# UNITED STATES PATENT AND TRADEMARK OFFICE

APPLICATION NO.	FILING DATE	FIRST NAMED INVENTOR	ATTORNEY DOCKET NO.	CONFIRMATION NO.
10/516,532	06/13/2005	Malcolm John Menday	15268-0001	4477

## Office Action Summary

## **DETAILED ACTION**

Fig. 2A

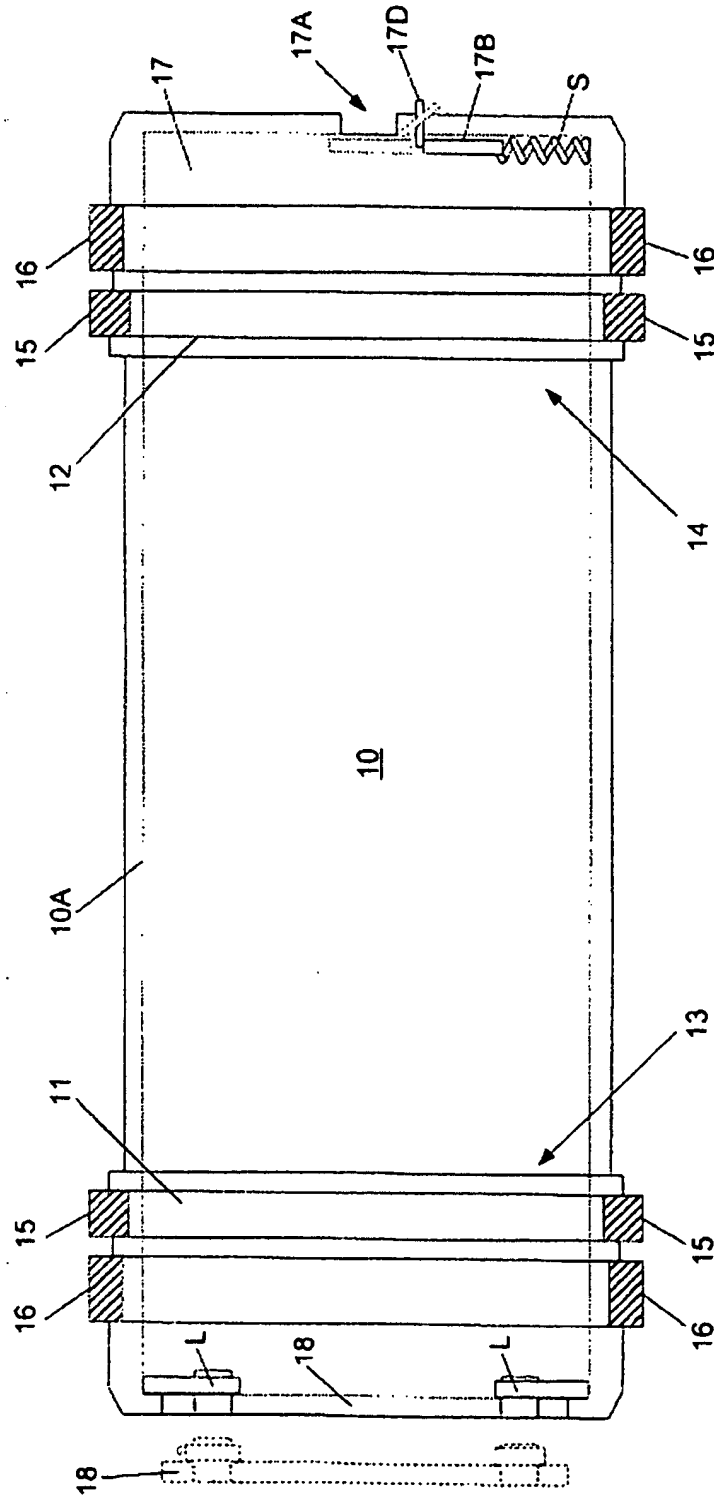
2. The proposed drawing correction of 6/27/06 has not been entered as containing new matter.

Do not  
Enter  
Ex. Allen
